SITE OBSERVATION REPORT

DATE:	April 16, 2016 Revised April 18, 2016
TO:	Kelly Wood
FROM:	Michael Pyszka
SUBJECT:	Inverness Force Main Site Visit
CC:	Tom Nielsen Rick Hermes

PROJECT NAME: Inverness 30-Inch Force Main Repair

MEMORANDUM

Photo 5 – Exposed exterior spiral reinforcement.

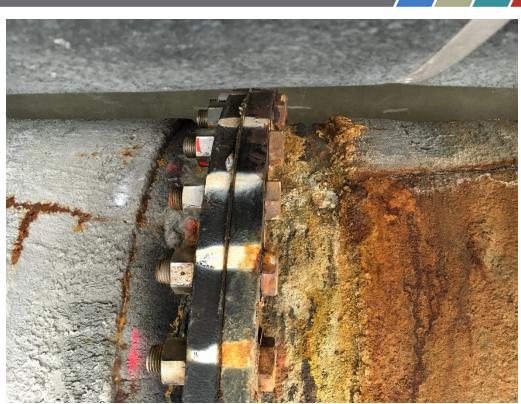
On the west side of the pipe between supports #8 and #9, a 2" diameter hole discovered after insulation was removed was enlarged to 4" by the contractor to view inside the pipe (Photo 4). The interior concrete and metal lining has disintegrated and the exterior spiral reinforcement is visible (Photo 5).

- For all holes greater than 2 inches in diameter, a two part epoxy should be used for repair. A stay-inplace form will likely be required on the pipe interior, and should be constructed as to not obstruct the
